STATEMENT OF ENVIRONMENTAL EFFECTS - ADDENDUM
122 & 124 Queenscliff Road QUEENSCLIFF
DA2022/0646 – Amended façade and solar access submissions

BBF Town Planners are instructed by the applicant, to submit this additional information in support of the subject Development Application. The information responds to matters raised in email correspondence from Council dated 15 June 2023. The submission is accompanied and supported by:

Figure 1 – excerpt of the western elevation showing the increased rear setbacks of each level

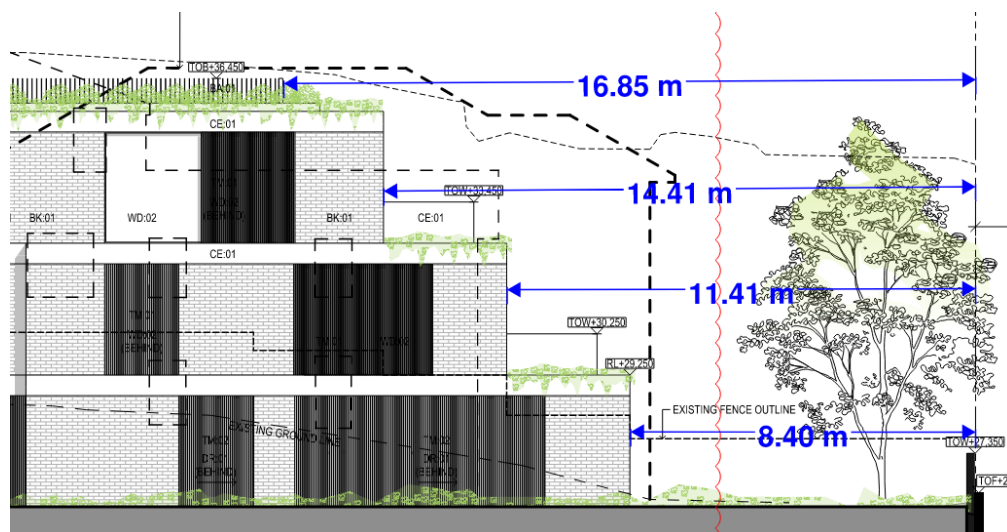
The proposed design is a site-specific design that incorporates a stepped rear façade and greater than the minimum rear setbacks (6m under the DCP, 8m under the Codes SEPP). The rear setbacks increase as the height of the building rises. The following rear setbacks are noted and illustrated in figure 1 below:

- Roof terrace – 16.85m
- Upper level - approx. 14.4m
- Middle level – approx. 11.41m
- Lower level – approx. 8.40m

Figure 2 – excerpt of the western elevation showing the increased rear setbacks of each level

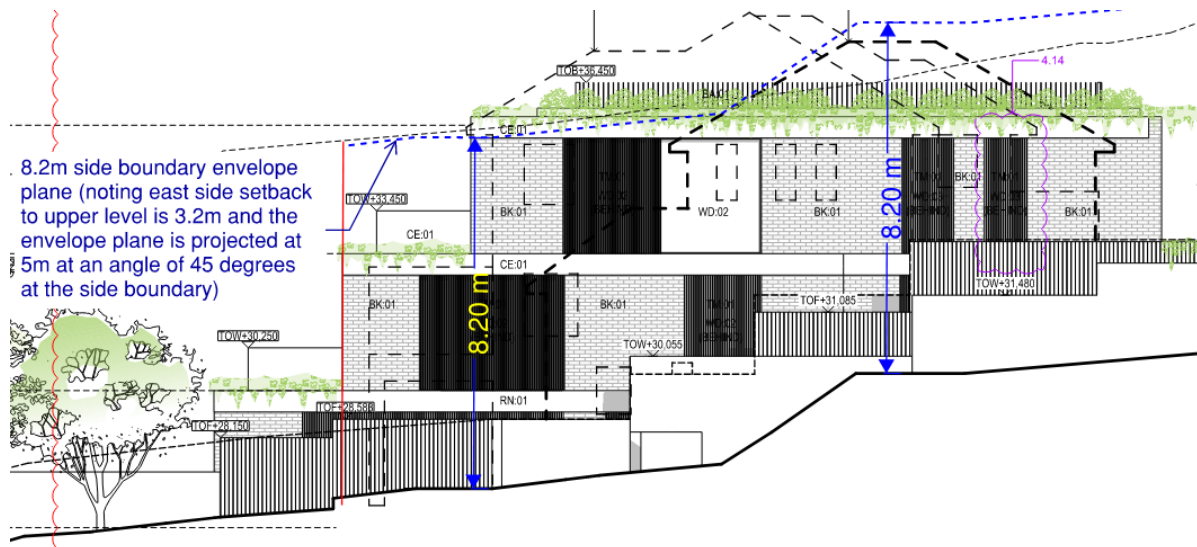
Further to the above, another key consideration is the height and setback of the building along its eastern side and at its south eastern corner. DCP control B3 Side Boundary Envelope regulates this aspect. As shown in figure 2 below, the proposal is very close to compliant with

this numerical requirement (addressed further in the addendum Statement of Environmental Effects dated 8 May 2023). The minor exception shown does not inappropriately contribute to the shading impact at 120 Queenscliff Road.
